RCA-60-22-001-1: Replace Underbody Panel Fasteners

Document Type	Customer Satisfaction Campaign Bulletin
Date	June 10, 2022
Affected Region(s)	USA
Affected Model(s)	R1T
Model Year(s)	2022
Approximate Build Dates  Refer to the FSA Dashboard to determine if this document applies to a specific vehicle.	August 2021 - November 2021
Vehicle System	60 - Exterior Attachments
Minimum Service Location	Mobile

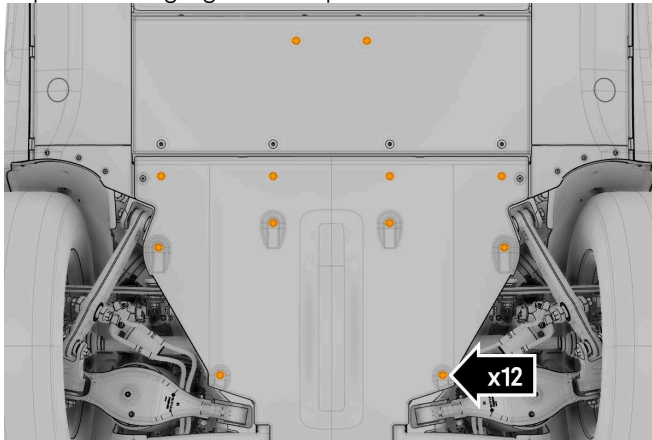
1. Raise and Support Vehicle (refer to service manual procedure 981020017).
2. Replace the highlighted component(s).

3. Replace the highlighted component(s).

Step Number	Torque (Nm)
2	9
3	9
